**Addendum to the Historic Report by Treanor HL
(Formerly Carey & Company)**

Hotel Montgomery and San Jose Tribute Hotel Project
211 South First Street
San Jose, California

ADDENDUM TO HISTORIC REPORT OF MAY 25, 2017

Figure 15. Solar study (TCA Architects, 2017).

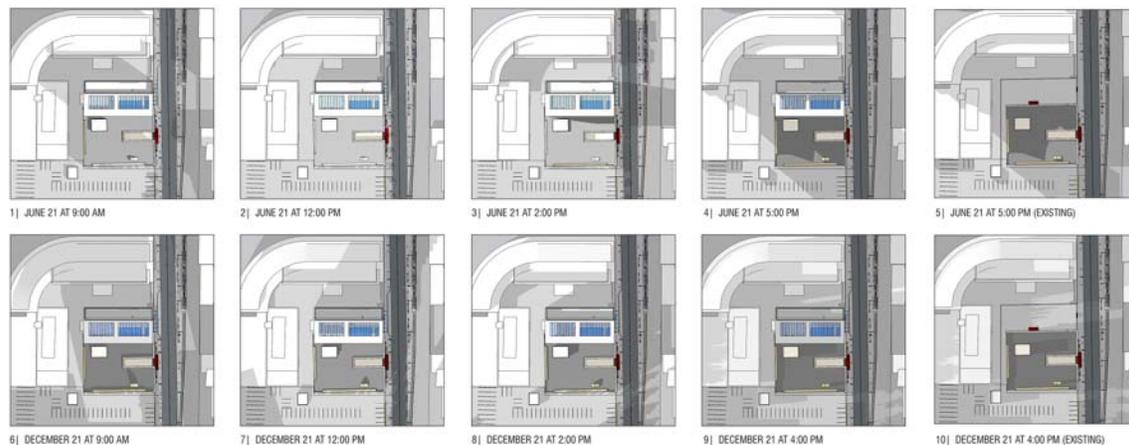
- *[Commissioner Raynsford] would also like an analysis of sunlight and shading around the building and what effect the cantilever will have on the historic building.*
- *Commissioner Raynsford wanted the report to address issues of ...shadowing...*³³

Figure 15 below illustrates the existing shadows, and the shadows cast by the project for June and December. The proposed tower sits north of Montgomery Hotel, so the tower will cast little direct shadow on the historic property except during the late summer afternoons.³⁴ The amount of new shadow cast on Montgomery Hotel would be relatively minor due to the short duration of the shadow and due to the limited period of the year when it would be cast. Therefore, the shadow cast by the proposed tower would not impair the significance of Montgomery Hotel. See attached Sheet A-6.0 Solar Study.

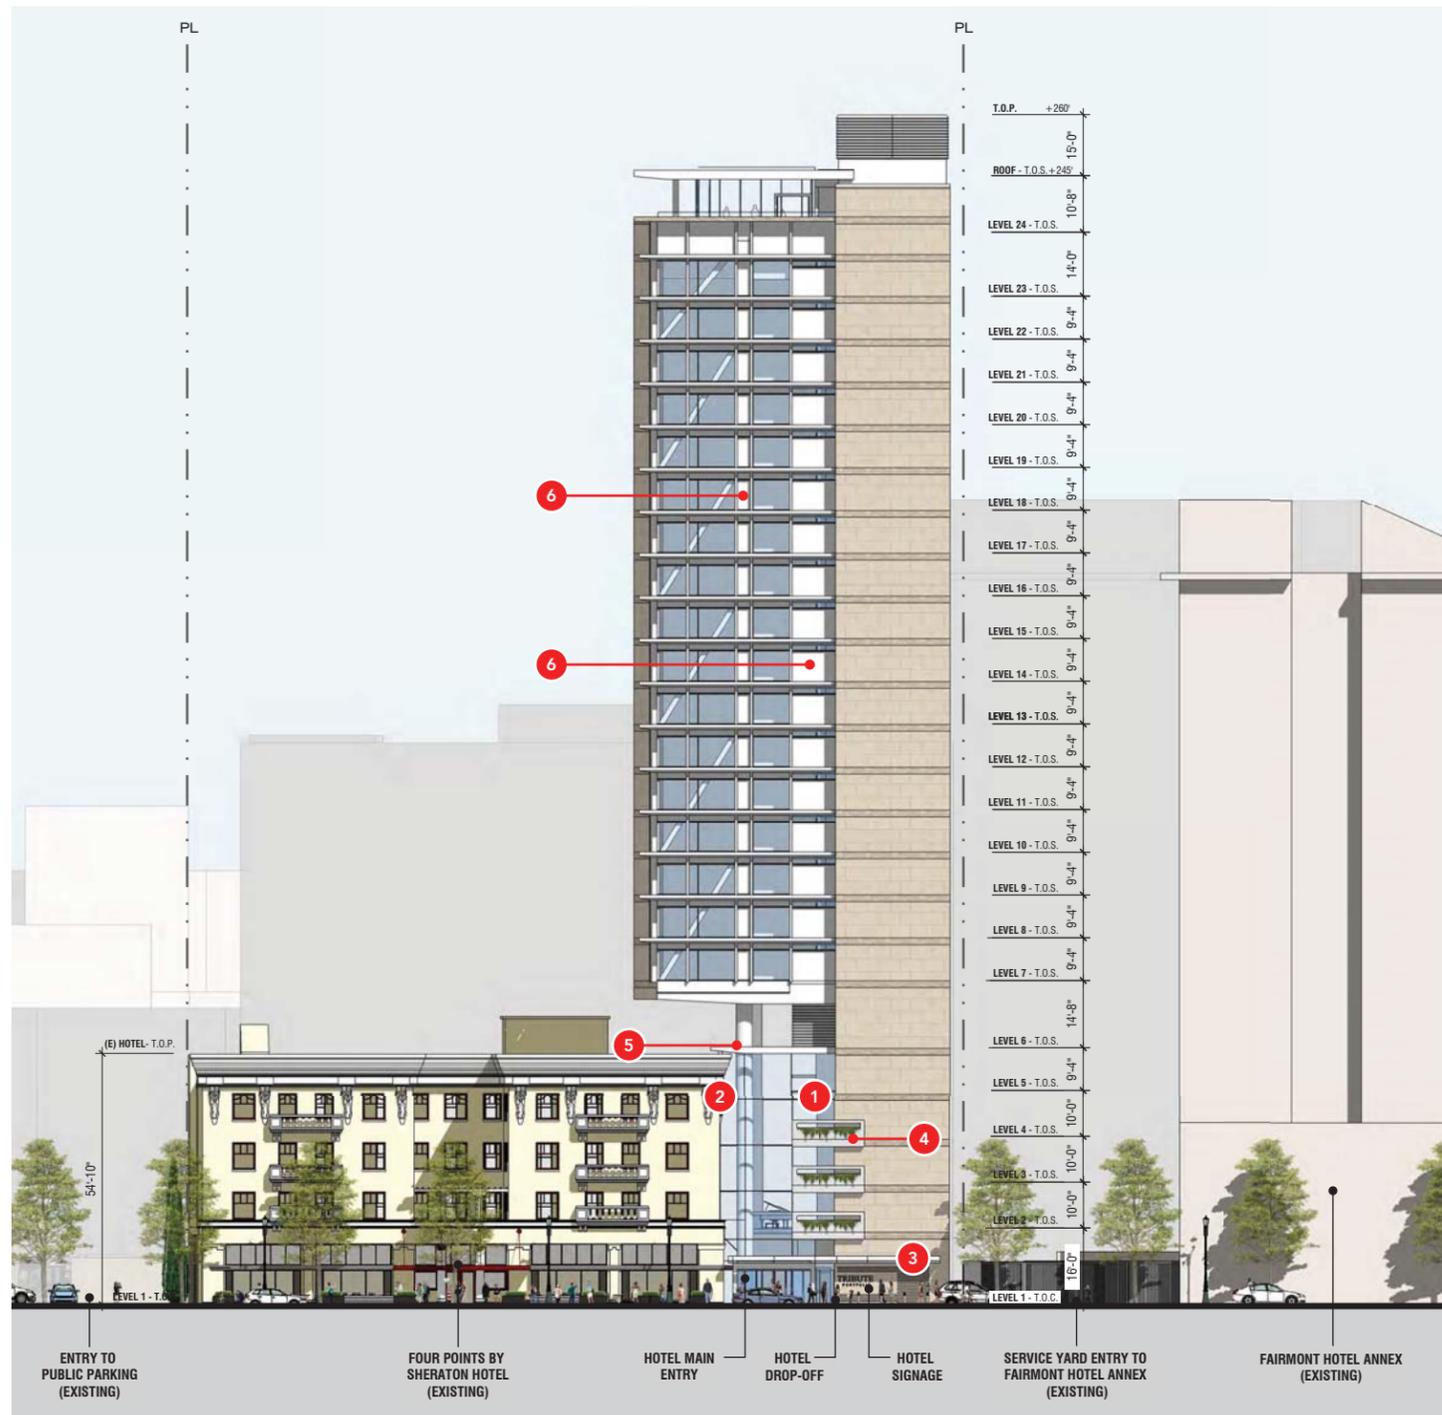
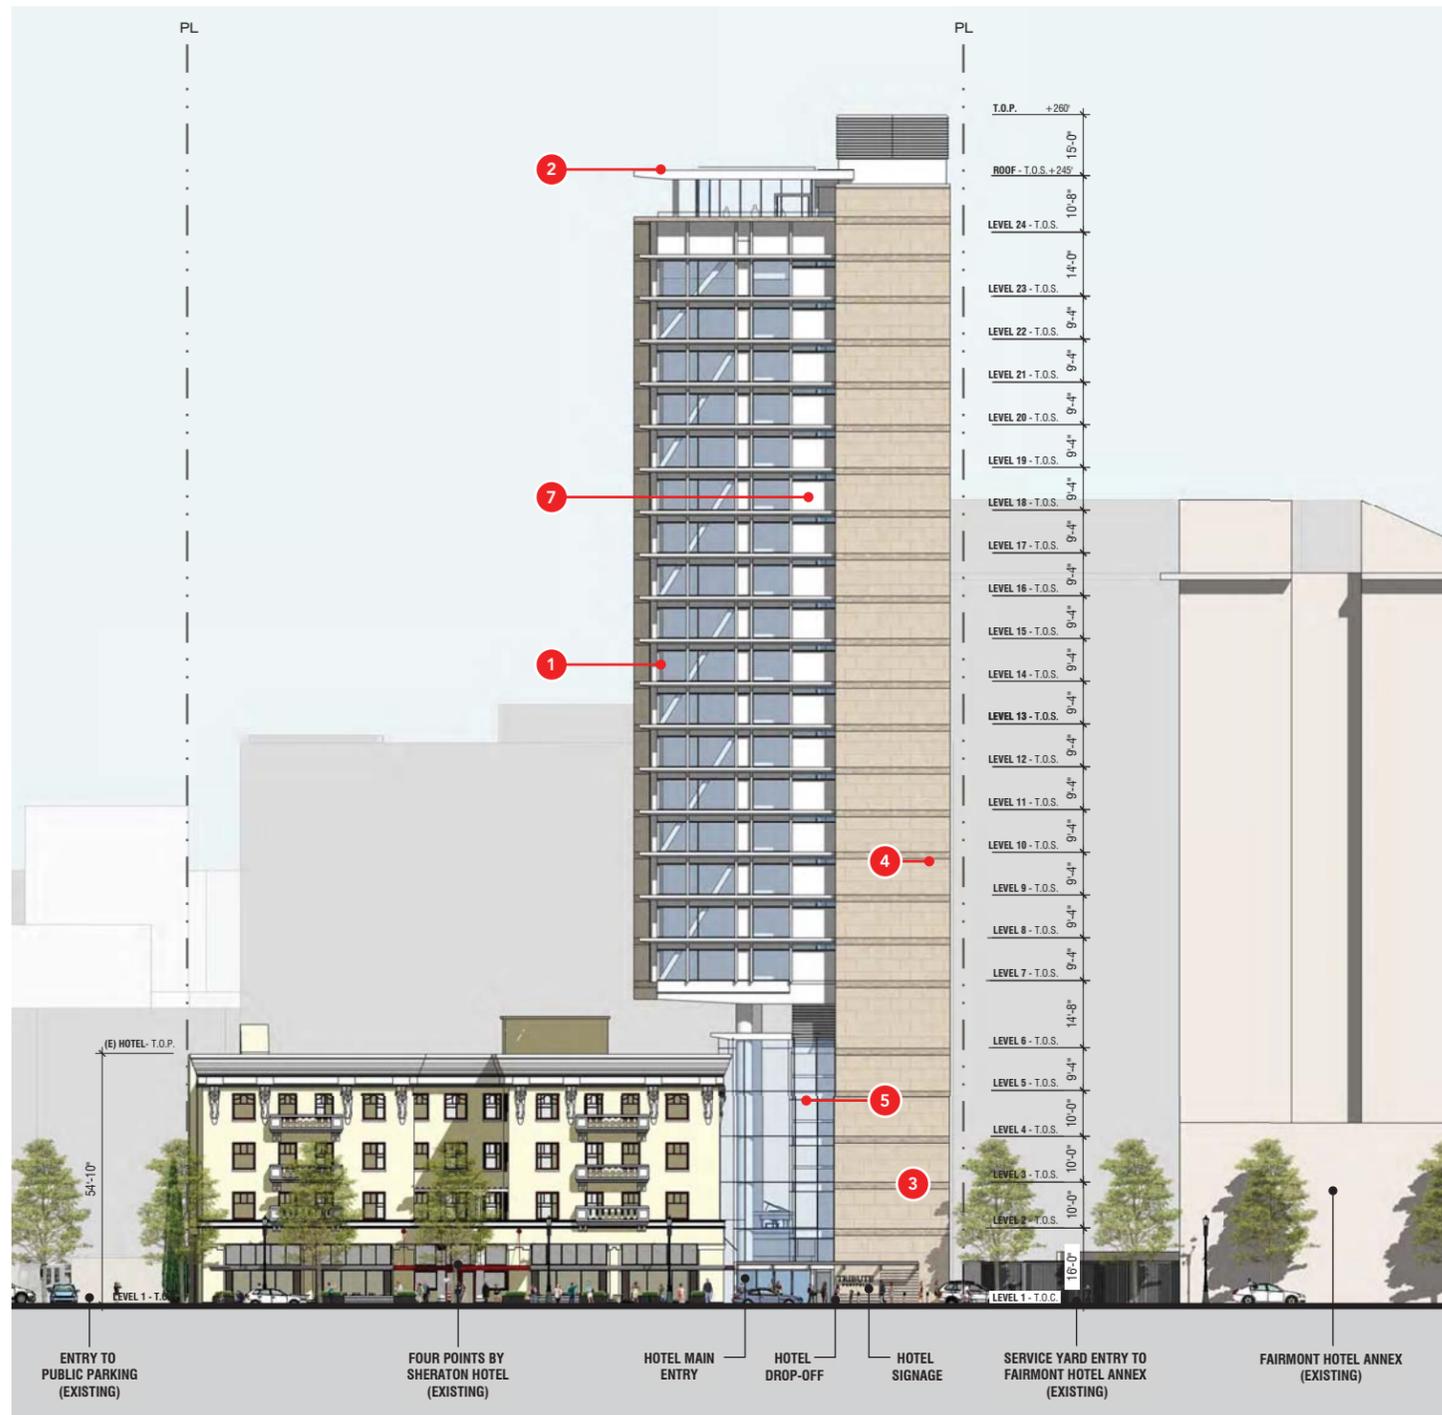
- 1 SET ATRIUM GLAZING BACK
- 2 DETAILING AT CONNECTION OF ATRIUM GLAZING TO BE REFINED
- 3 ENTRANCE CANOPY TO BE LIGHTENED
- 4 BALCONIES TO BE REMOVED
- 5 ADJUST POSITION OF SKYLIGHT FRAMING
- 6 OPAQUE PANEL TO REDUCE GLAZING AREA

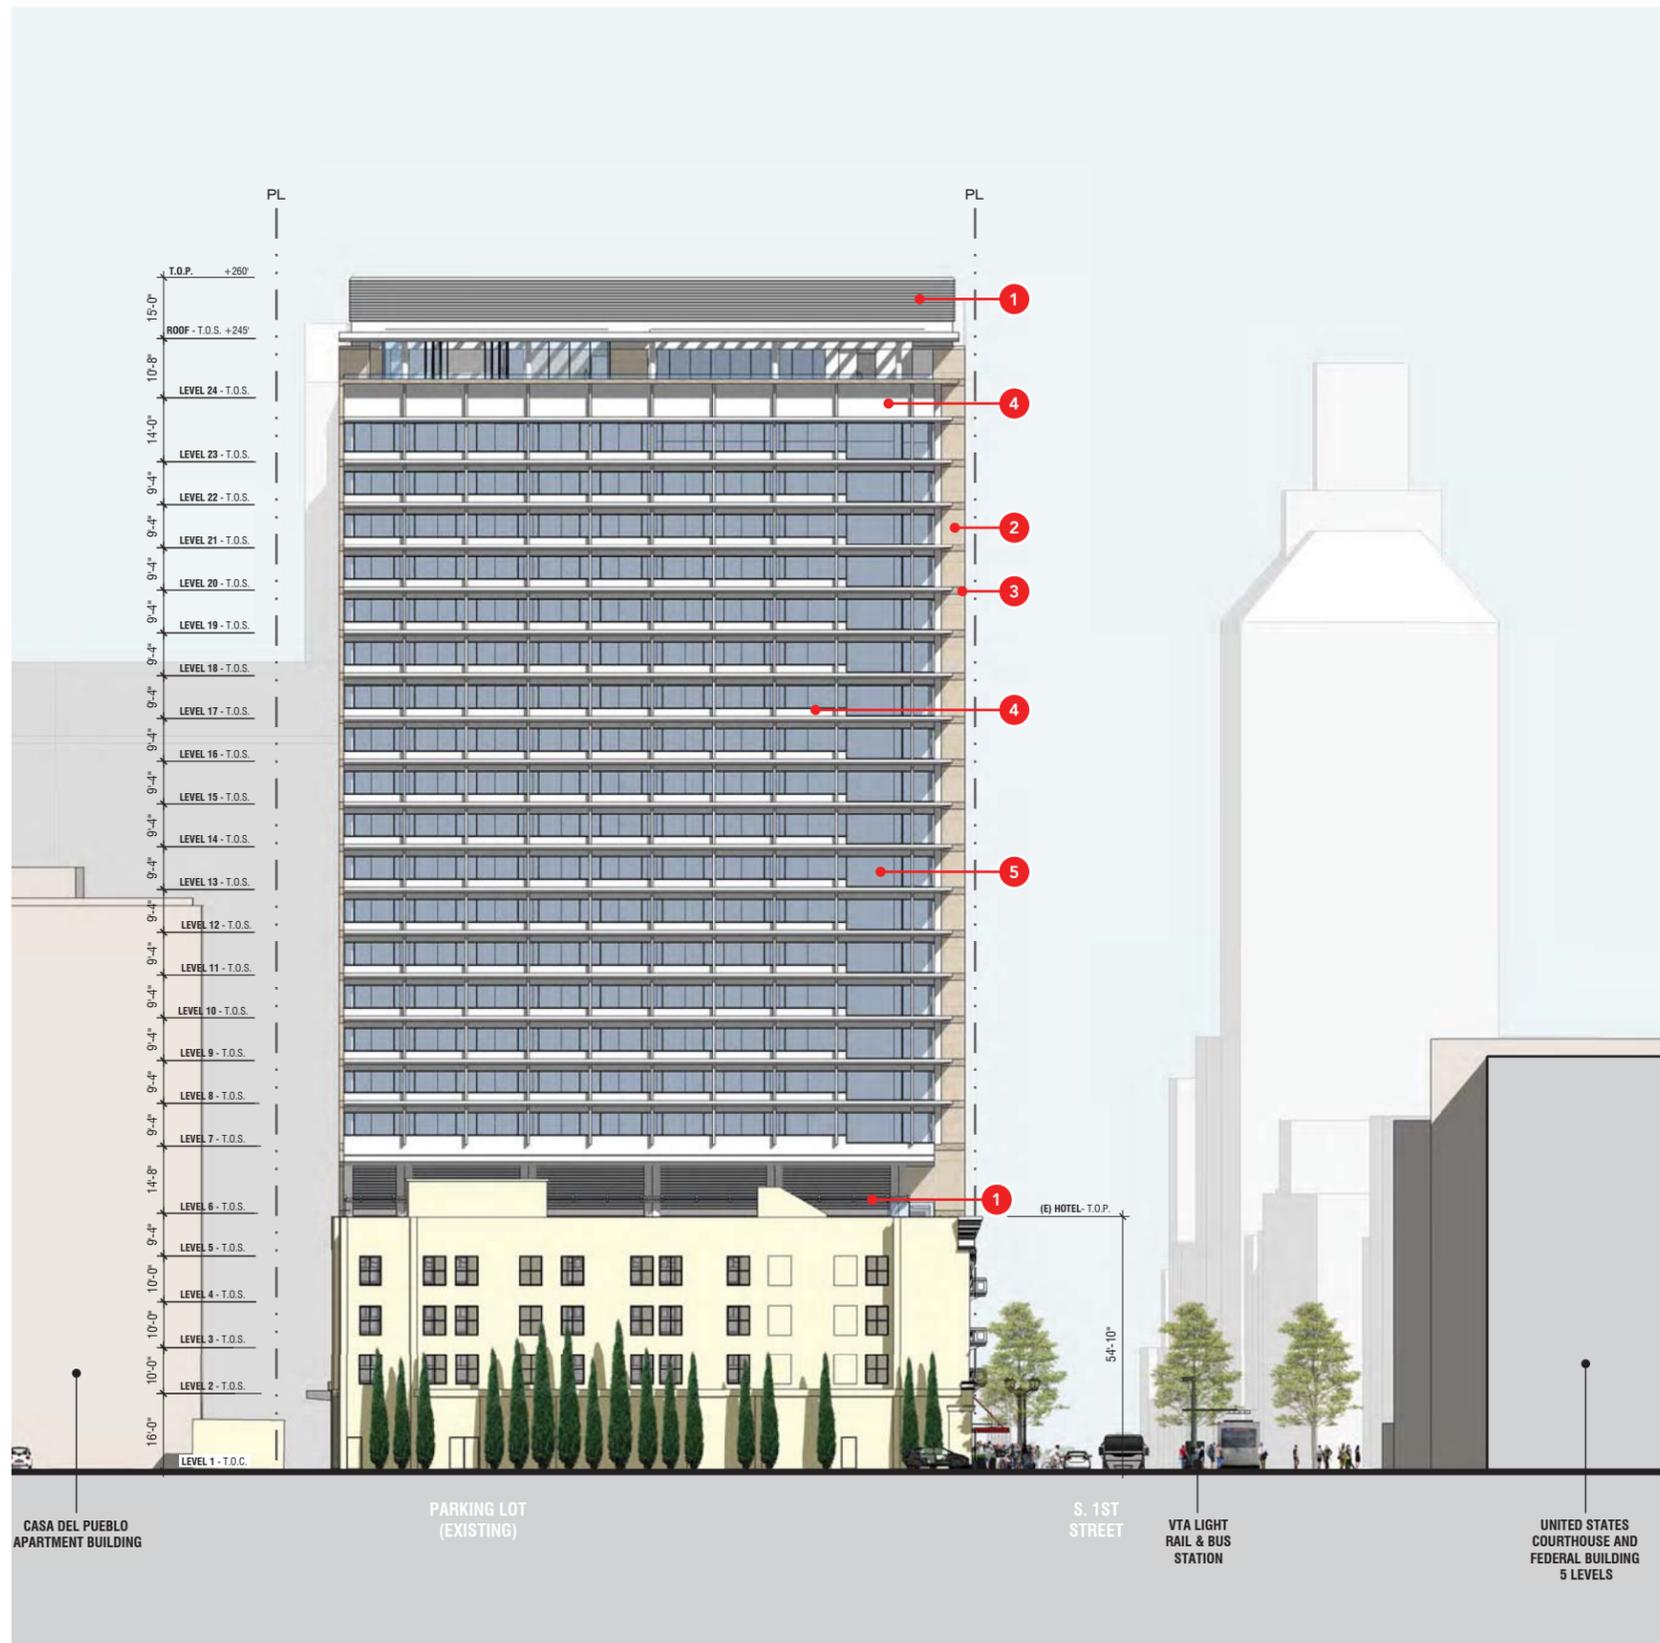
- 1 REFINE CORNER OF TOWER TO BE MORE TRANSPARENT, CANTED SOUTH FACE TO OFFER GESTURE DEFERENTIAL TO THE EXISTING HOTEL
- 2 ROOFTOP CANOPY TO BE ENHANCED AND RAISED FOUR FEET AND OUTBOARD EDGE WRAPPED AROUND THE PERIMETER OF THE PENTHOUSE TO GIVE MORE PROMINENCE
- 3 EAST, NORTH AND WEST WALLS TO BE REFINED WITH COLOR

- 4 NORTHEAST AND NORTHWEST CORNERS OF THE TOWER TO BE REFINED WITH RECESSED BANDS - A MODERN VERSION OF QUOINS - TO MODULATE THE SCALE AND PROVIDE VISUAL INTEREST
- 5 RECESS BALCONIES TO SPANDREL DEPTH AT ATRUM ENCLOSURE
- 6 RECONFIGURE EXPRESSED TOWER ELEMENTS INTO UNIFORM GRID TO HEIGHTEN CONTRAST WITH CORNER BAY
- 7 DEVELOP ARTICULATION AND REFINE BUILDING SCALE
